U-ESR-H-00128

April 2015

Revision 0

Tank 16 – Response To NRC Comments On Closure Module

Figure 2: (Area at STA 5+00 estimated to a height of 8 inches in 2012. Attachment SRR-LWE-2012-00039)

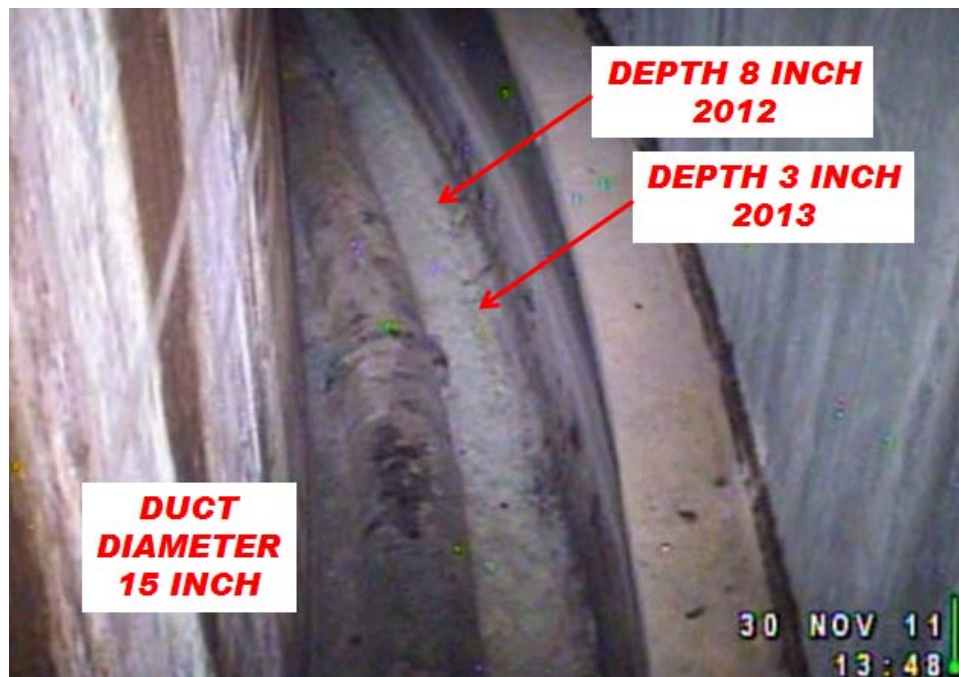
The documentation in the Closure Module could better explain why many of the visual observations from 2011-2012 were replaced with new assumptions. It seems that the photo technology would not have changed much from 2011 to 2013 to yield such different results. The differences between the use of landmarks or visual assumptions applied in SRR-LWE-2012-00039 versus U-ESR-H-00113 could be better explained. Specific examples are also provided in the following comments.

Photographs of STA 5+00 below show an area that was revised from 8 inch height in 2012 to 3 inch height in 2013. Waste height outside the duct at STA 6+00 was assigned a height of 2 inches based on interpolation of the 2 inch measured height at STA 7+00. The photograph from 2012 was used to assign a height of 8 inches to this area without close sampling measurements (Figure 2). The closest sampling data in 2012 was from 20 feet away. This value was believed to be the most realistic height based on the visual evidence at the time. The 2013 sampling effort at STA 3+50 indicated a height of 3 inches. Photo I from U-ESR-H-00113 displays the area in more detail (Figure 3). The measured sample height of 3 inches was assigned to this area because it was believed that Photo I was consistent with a height of 3 inches.

These two examples were areas of large height change from the 2012 volume estimate to the 2013 volume estimate. As is illustrated from the included photos, lighting and the angles can make objects appear differently. The team that estimated the annulus volume in 2012 also estimated the volume in 2013, providing continuity and historical knowledge. Solids heights were a consensus agreement by the subject matter experts. The final report and estimation was verified / checked by an independent, qualified person.

Figure 6: (Area at STA 1+80 measured at 4 inches. Photo E U-ESR-H-00113)

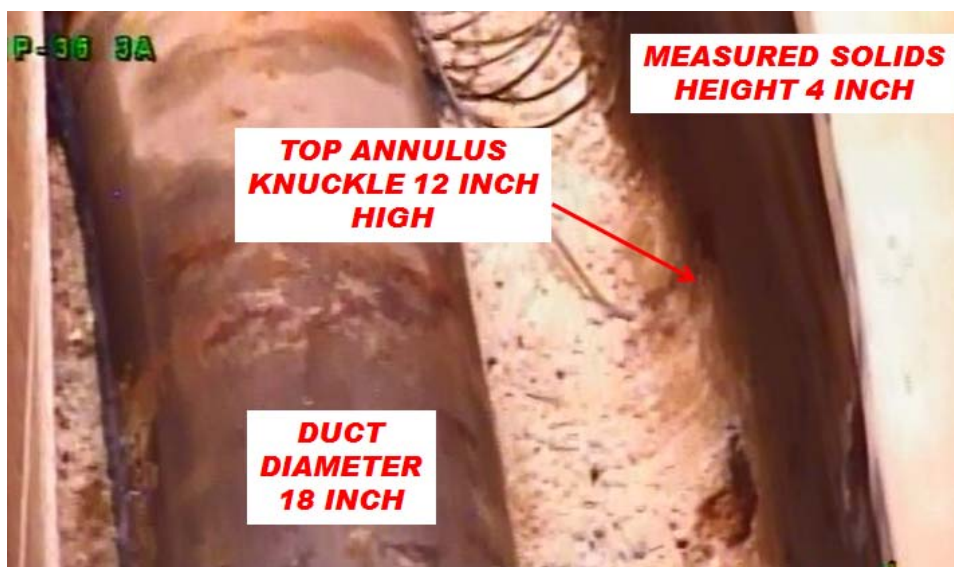
In general, the potential discrepancies between the measurements and what is observed in the photos using the landmarks could be better addressed. For example, it would be helpful if the photographs from similar locations from both 2011 and 2013 could be analyzed side by side, with the landmarks and depth assumptions clearly labeled. Information available from the measured samples could be discussed in terms of how it relates to the landmarks in each of the photos with any ambiguous or conflicting observations explained. Could DOE explain the visual evidence that supports the reduction in height for waste outside the duct near Stations 2, 3, 8, and 10?

The measured height at STA 1+80 was 4 inches in 2013. This is consistent with the measured value at South Riser STA 0+00 in 2012. A photo of the area in question is provided below (Figure 6). There are no landmarks in the area that are close to being 4 inches tall. The annulus knuckle has a 12 inch radius and the duct steel band joint is approximately 8 inches off the floor. Note that the steel band joint appears higher on the left side (Figure 7). If the steel band was configured with the joint horizontal, the level of the joint would be 10.4 inches. The solids layer in this area is below all available landmarks. There is no evidence to suggest that 4 inches is not an accurate depth for this area.

Figure 10: (Area at STA 10+00 interpolated to a height of 3 inches. Photo M U-ESR-H-00113)

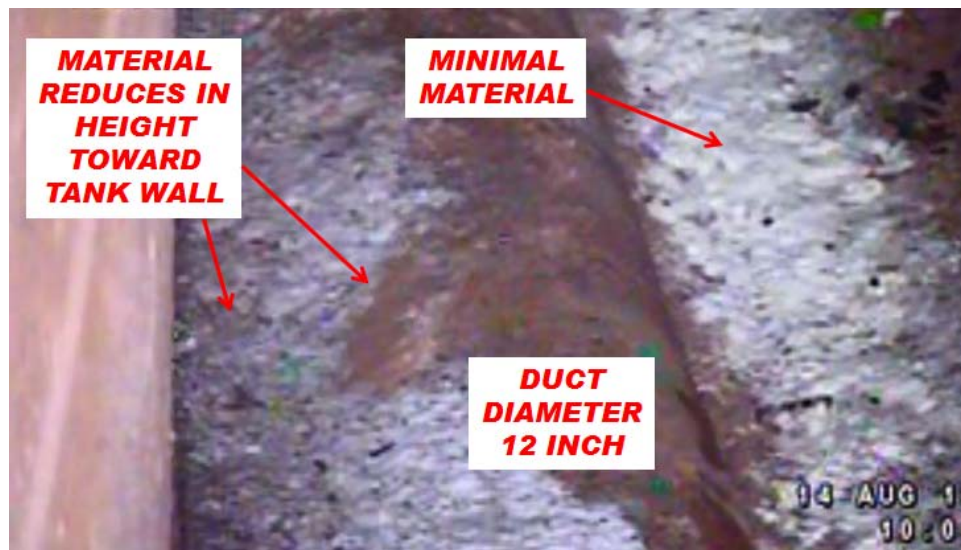
Could DOE describe the visual landmarks used in Photo M to support the height assumption at that location? Or, if instead, the height of the annulus waste near Station 10 is based on interpolation between nearby sampling locations, could DOE describe why the photographs near this Station were not used?

The interpolated height from the nearest measured heights (3 inches) was assigned for this area, and evaluation of visual evidence did not result in adjustment to the interpolated height. Visual depth perception was a factor in the decision to not adjust the interpolated height. A photo of the area is included below (Figure 10).

As stated in our methodology, an interpolation between measured sample heights was used in conjunction with visual observation to assign a height to the material in this area. STA 10+00 is an area between two measured values of 2 inches and 5.5 inches. Visual evidence suggests that the solids height did not increase between the two sample locations, therefore the value at STA 10+00 would be 5 inches or less. There is a minimal amount of material to the right side of the duct, material is coating the left side of the duct, then the material appears to decrease in height away from the duct to the left (Figure 10). Several data points were used to assign a value:

The interpolated height from the nearest measured heights (3 inches) was assigned for this area, and evaluation of visual evidence did not result in adjustment to the interpolated height. Visual depth perception was a factor in the decision to not adjust the interpolated height.

Figure 14: Vertical Rack

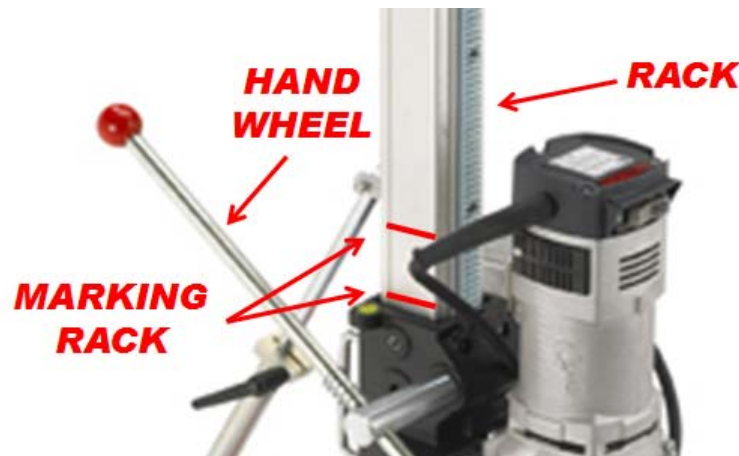
- a. Is reaching the top of the waste based on visual observation, or some other indicator?
- b. How variable are the waste height measurements due to surface roughness? If the surface of the waste is rough or variable along the radius, then there may be significant uncertainty in the height measurement in roughly the same measurement location.

The drill rig used is similar to the one pictured below (Figures 13 and 14). Vertical moment is controlled by the handwheel. The gear on the handwheel interfaces with a rack on the vertical column to hold or adjust vertical position. Marking and measuring vertical position on the column is simple and accurate. Uncertainty in this measurement would be very low.

Figure 16: Material Accumulated on Annulus Knuckle

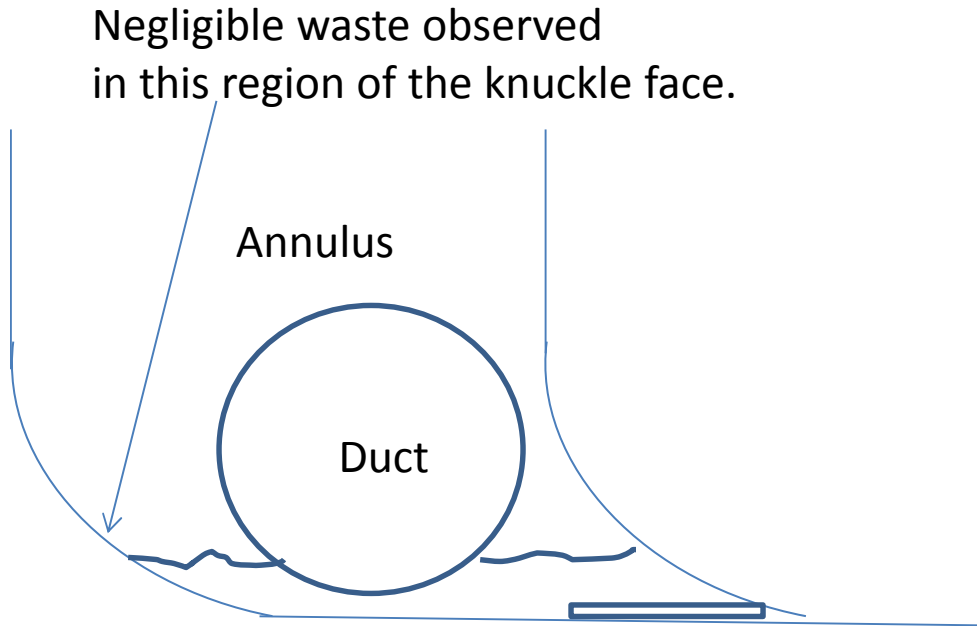
- c. How variable are the waste heights based on distance from the annulus wall or duct (i.e., does waste tend to accumulate on vertical surfaces)?
- d. It is not clear how one would determine when the top of the waste is reached in a duct where the duct itself is obstructing the view? How would one know when the auger reaches the top of waste in a duct in cases where a hole needs to be cut into the duct to sample (e.g., photograph H in SRR-LWE-2014-00151)?

Generally, solids were not observed accumulating on vertical surfaces (Figure 15). In some areas where solids height was minimal along the outside of the annulus, the level appears to conform to the curvature of the knuckle. Volumes estimated in these areas are determined according to the mapping team's judgement and experience. This was accounted for in the uncertainty values.

Figure 20: Annulus Duct Split

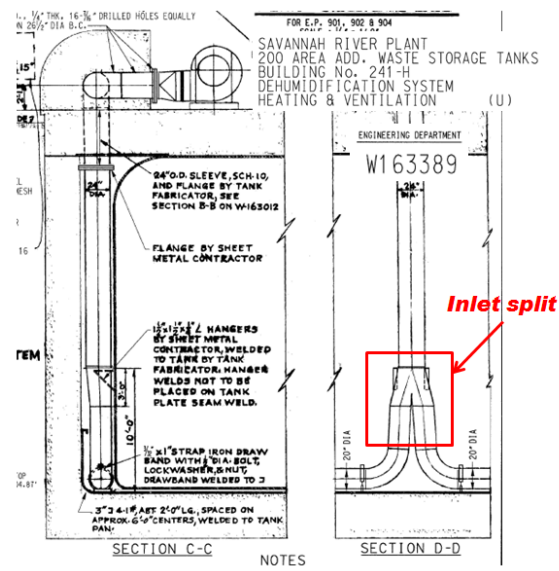
It is not clear how heights are determined for Tank 16H annulus waste located inside the duct between Stations 20.70 and 00.30 in the absence of sample measurements and photographs (SRR-LWE-2014-00151).

The documentation could better explain the extrapolation method used for areas lacking sample or photographic data (e.g., it does not appear to be a linear interpolation based on segment length). In looking at the depth assumptions listed in the spreadsheet in Figure A4-1: Tank 16H Annulus Residual Solids Chart of U-ESR-H-00113, it appears that the measured heights were entered at the various stations and an approximate interpolation between those measured heights was assumed. Also, as stated above in the comments regarding visual observation, it is unclear how the photo observations and landmarks helped inform the interpolated values.

The area between STA 20+70 and STA 0+00 is discussed in assumption 3.2.1.3 in U-ESR-H-00113:

- Annulus duct solids level is assumed to abruptly change at Station 22+00.

Justification: This is the inlet of the annulus exhaust and the duct splits into two at an elevation well above the solids level on the floor. Therefore the two horizontal halves of the duct are not connected at this point. Since there is no visual evidence otherwise, it has been assumed that the solids level inside the duct on either side is similar to the level measured during sampling. This remains conservative as the highest observed levels on each side of the split duct are assumed and there is no reduction taken for the gap in the duct as it rises (see Figure 20, which is Figure 3.2-2 in U-ESR-H-00113).
